TOWN OF BLUFFTON CERTIFICATE OF APPROPRIATENESS- OLD TOWN BLUFFTON HISTORIC DISTRICT (HD) APPLICATION

Project Description: 61003900A0183 36 Wharf Street Design Certificate of

Project Description: COFA-01-22-016241

Date: Tuesday, 17 Feb 2022 Project Location: 36 Wharf Street

Transportation Department Review_C. Clarkson

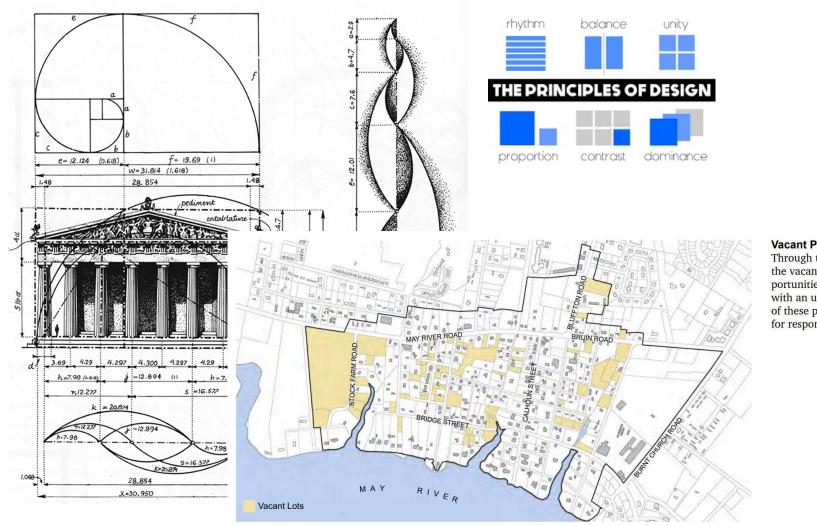
1 : ...likely that a +/- 5' easement will be needed along the Wharf Street frontage... CIP division would like to inquire about the Applicant's willingness to provide a +/'5' easement to accommodate the proposed Wharf Street Lighting project.

Response: We are willing to comply, a 5' easement will be shown on the final submitted site plan, and requests all proposed plans, data, and public meeting notes for the project.
